March 15, 2011
U7-C-NINA-NRC-110043

South Texas Project
Units 3 and 4
Docket Nos. 52-012 and 52-013
Revised Response to Request for Additional Information

RAI 03.07.02-22**QUESTION:****Follow-up Question to RAI 03.07.02-12 and 03.07.01-13 S2 (STP-NRC-090129 & 090230)**

Figure 3H.6-218: SSI, SSSI, ASCE 4-98 and Design Lateral Seismic Soil Pressures on RSW Pump House South Wall

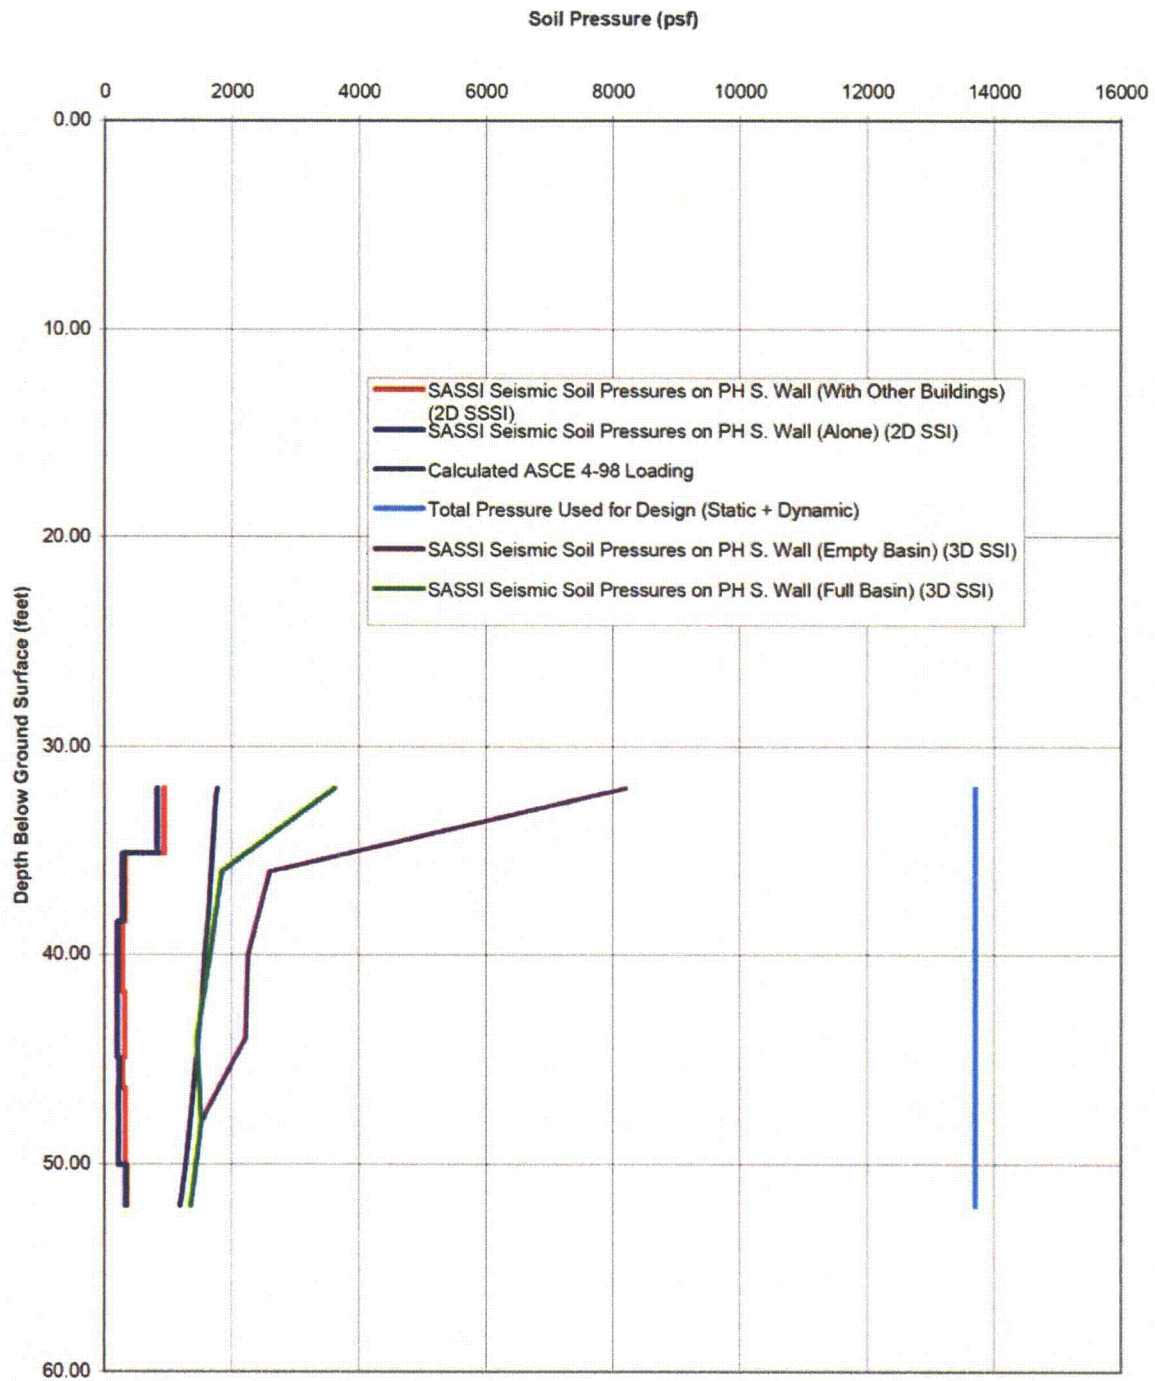
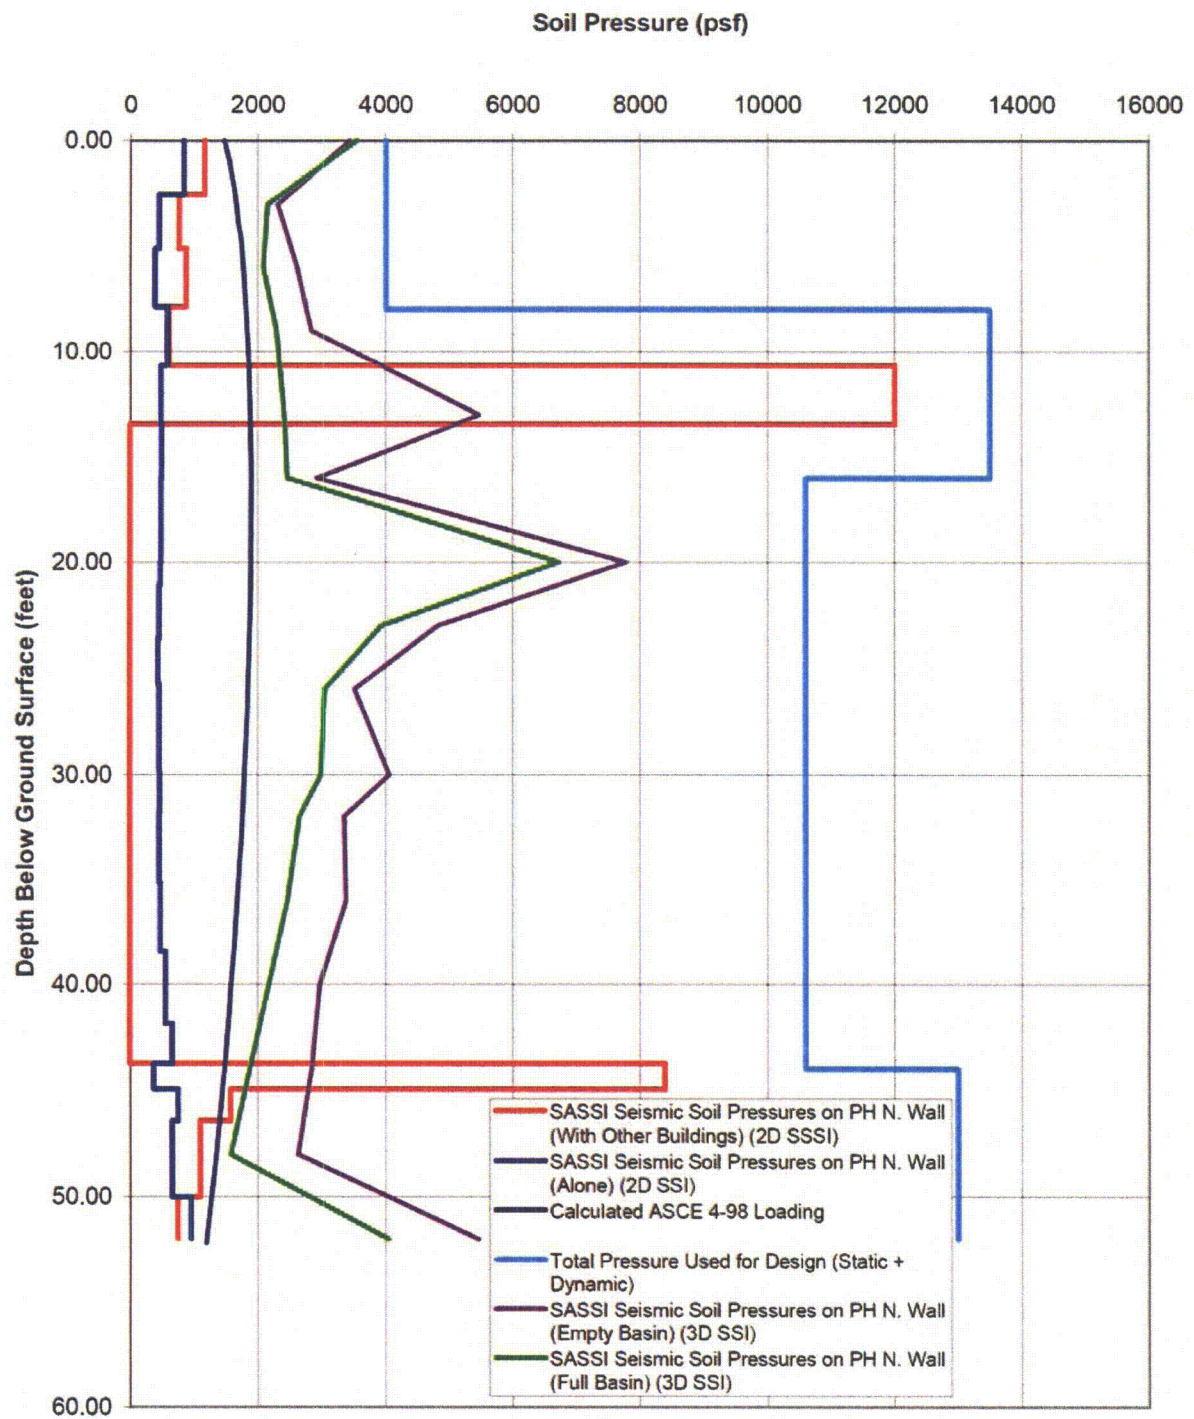
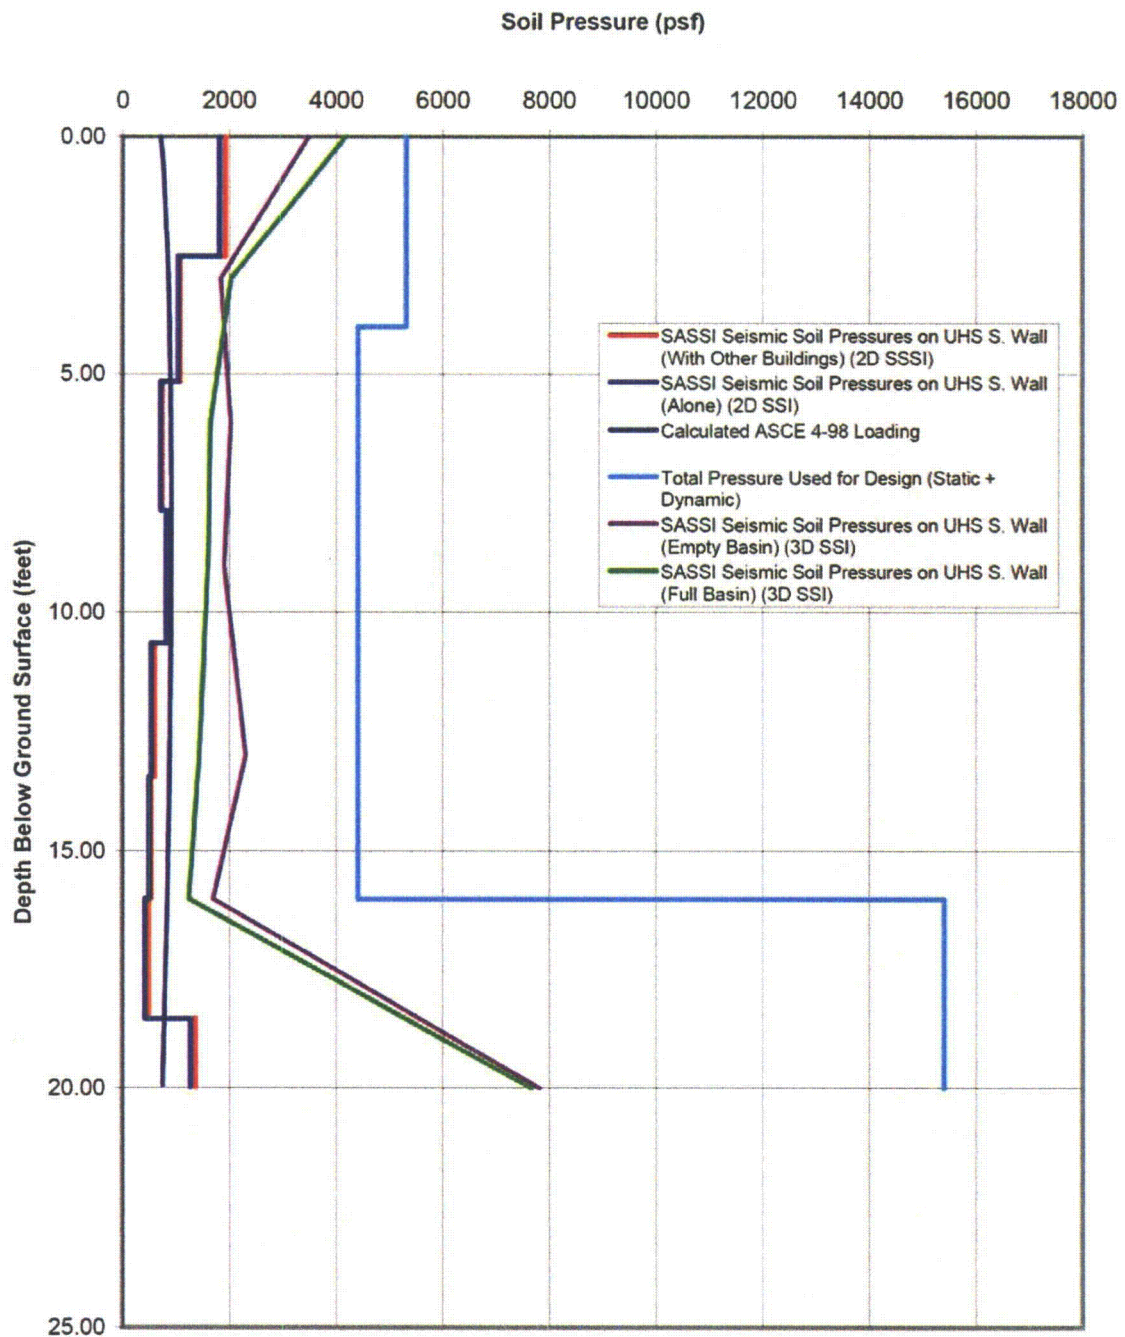
10CFR50, Appendix S requires that evaluation for SSE must take into account soil-structure interaction (SSI) effects. In the response to RAI 03.07.02-12 regarding the dynamic soil pressures on the UHS Basin and RSW Pump House, the applicant has provided the calculated pressures that include the effect of SSI in Supplement 2 response to RAI 03.07.01-13 (see letter U7-C-STP-NRC-090230 dated 12/30/2009). A comparison of the envelop of calculated soil pressures on the RSW Pump House and UHS Basin walls calculated from the SSI analysis (Figure RAI 03.07.01-13A and RAI 03.07.01-13B in the Supplement) and those calculated using the ASCE 4 procedures (shown in Figures 3H.6-41, 3H.6- 42 and 3H.6-43 of the same supplement) reveals that for the UHS Basin, the SSI pressures for the west and east walls are significantly higher than those of ASCE 4 (approximately by a factor of 2 or more everywhere). For the UHS Basin north and south walls, the SSI pressures are higher at all points but, in particular, significantly higher near grade. For the RSW Pump House, the overall difference between the magnitude of the calculated SSI and ASCE 4 pressures are less than those of the UHS Basin but the distribution of the pressures are different. As such, use of pressures using the methodology of ASCE 4 may under predict the pressure loads on the wall and thus, could impact the wall designs. As such, the applicant is requested to provide justification for not using the dynamic soil pressures calculated from the SSI analysis for design of the UHS Basin and RSW Pump House walls that takes into account the inertia effect of the structure and SSI effects.

Design of the Ultimate Heat Sink (UHS) and Reactor Service Water (RSW) Pump House has been revised to consider, in addition to incremental seismic soil pressures per ASCE 4-98, incremental seismic soil pressures from soil-structure interaction (SSI) analyses for full and empty UHS basin cases and incremental seismic soil pressures from structure-soil-structure interaction (SSSI) analysis.

Figures 3H.6-218 through 3H.6-220 (see Enclosure 1) provide incremental seismic soil pressures from the SSI analysis, SSSI analysis and per Subsection 3.5.3.2.2 of ASCE 4-98 as well as total soil pressure used for design of RSW Pump House south wall, RSW Pump House north wall, and UHS basin south wall, respectively.

**Figure 03.07.02-25.1: Node locations for spectra comparison on Original SSI Model
(North is along Y-Axis)**

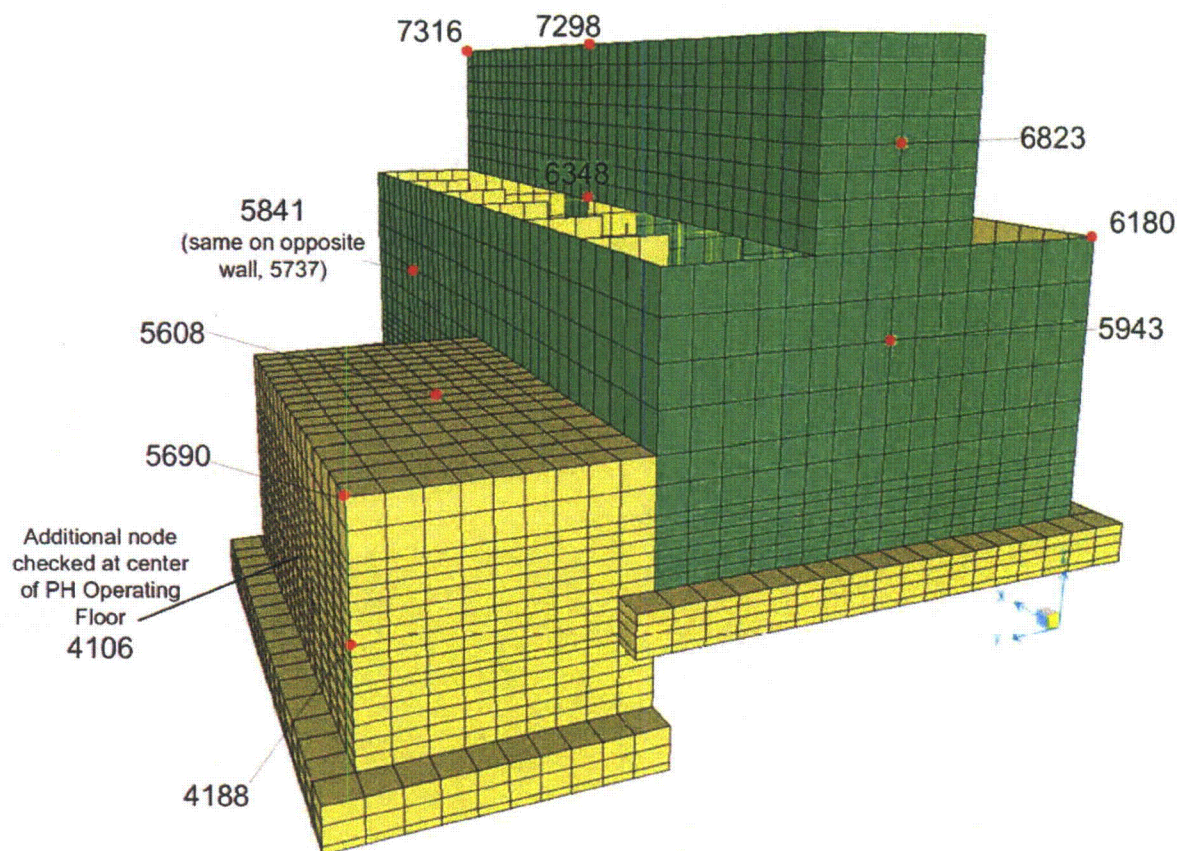
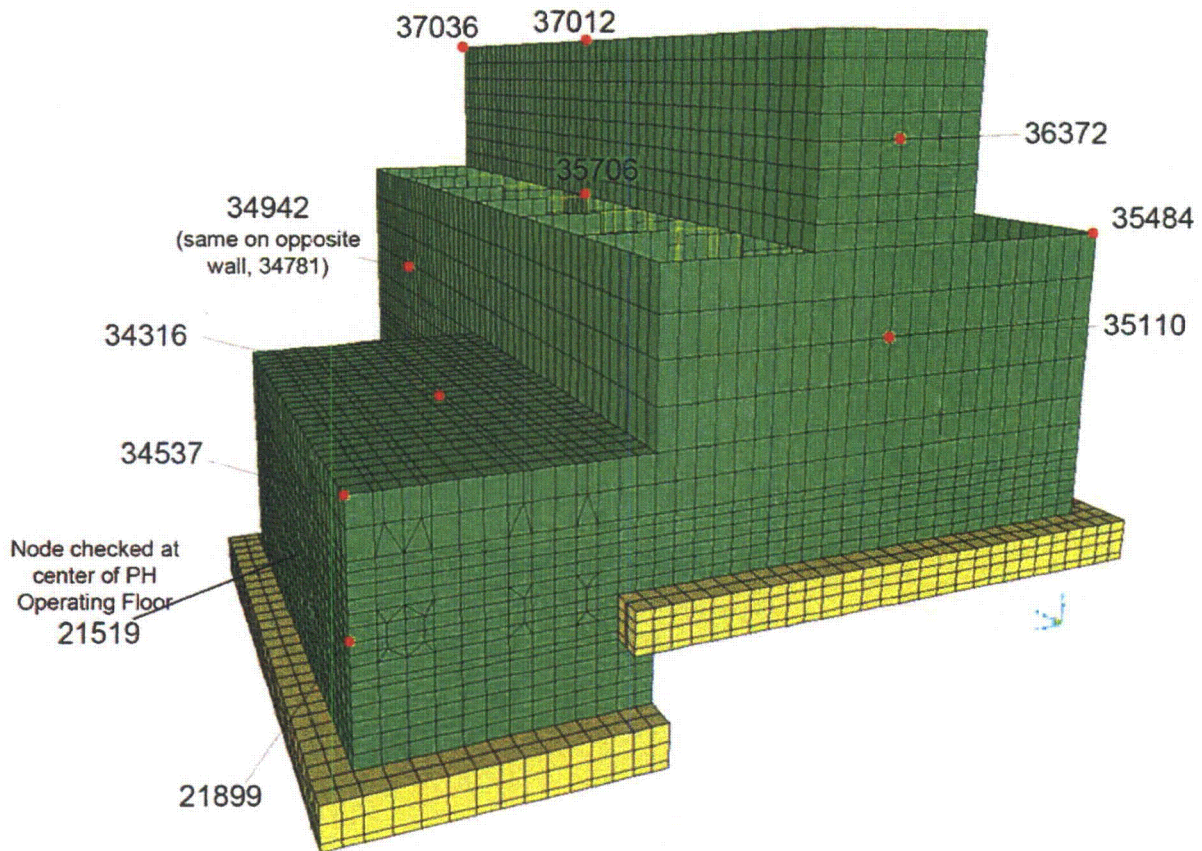
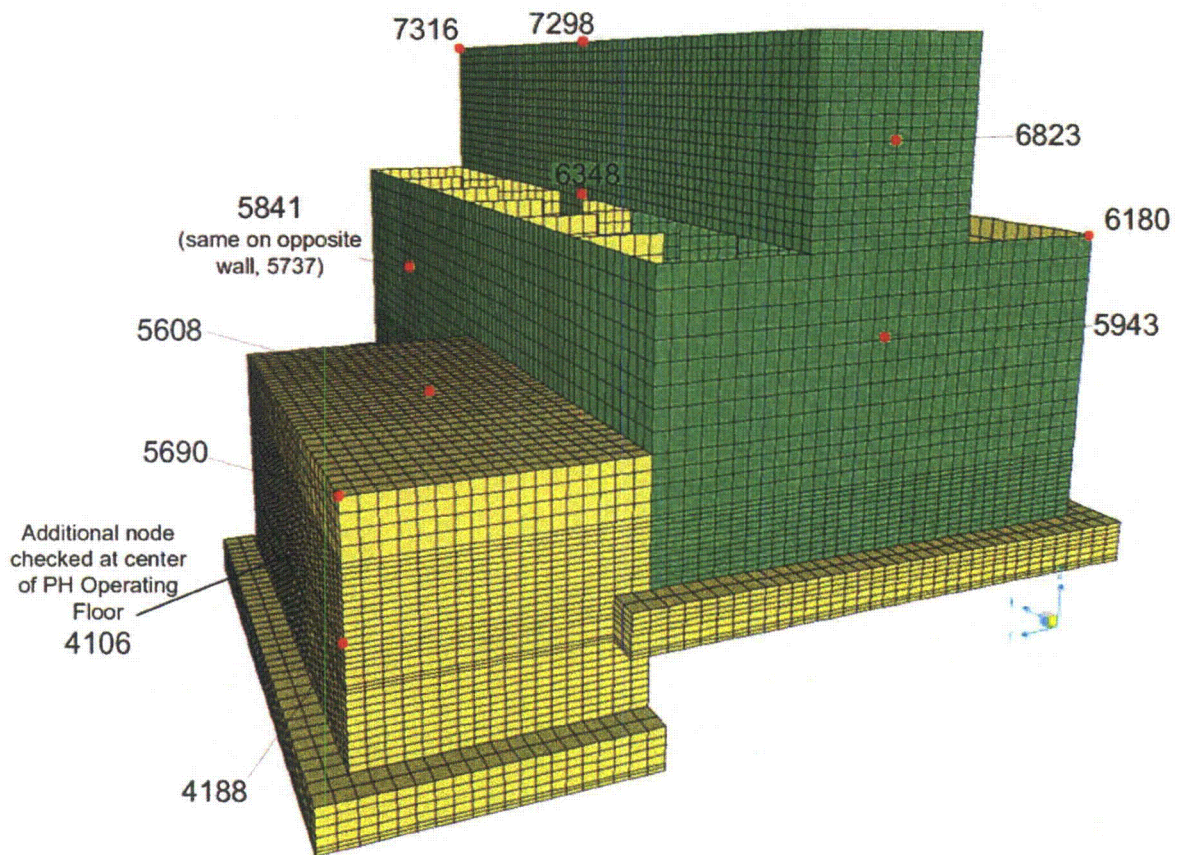
10CFR50, Appendix S requires that evaluation for SSE must take into account soil-structure interaction (SSI) effects. In the response to Item 1 of RAI 03.07.02-16 with regard to the adequacy of the structural mesh size used in the SSI analysis, the applicant has presented comparisons of the first two modes of the fixed-base structure in the E-W direction ($f_1 = 2.133$ and $f_2 = 2.056$ Hz) and N-S direction ($f_1 = 3.187$ and $f_2 = 3.028$ Hz) calculated using the SSI and design meshes. Although the comparisons of the two modes are good, they only represent a mass participation of about 17.1% and 15.4% for the E-W and N-S directions, respectively. In addition, the local modes are not reflected in these comparisons. As such, the applicant is requested to provide comparisons of the higher modes that include the out-of-plane modes of the slabs and walls to ensure the adequacy of the SSI mesh for transmitting frequencies of at least 33 Hz. This should include comparisons of in-structure response spectra of slabs, roofs and wall panels for the fixed-base structure calculated using the coarse SSI and fine design meshes subject to representative horizontal and vertical foundation motions. The staff needs this information to determine that the coarse mesh size (for modeling the structure) used in the SSI analysis is adequate for evaluation of SSI effect.

- Figures 03.07.02-25.1 thru 03.07.02-25.3 show original SSI model, refined SSI model, and refined structural model, respectively. Figures 03.07.02-25.6 thru 03.07.02-25.8 show Pump House roof to the same scale from the original SSI model, refined SSI model, and refined structural model, respectively.

- The node locations for comparison of in-structure response spectra are shown in Figures 03.07.02-25.1 thru 03.07.02-25.3 for the original SSI model, refined SSI model, and refined structural model, respectively. These locations include the Pump House Operating Floor, Pump House Roof, UHS Basin Walls, and UHS Cooling Tower Walls. The node locations for comparison of maximum accelerations, in addition to those locations for comparison of in-structure response spectra, include those shown in Figures 03.07.02-25.4 and 03.07.02-25.5.
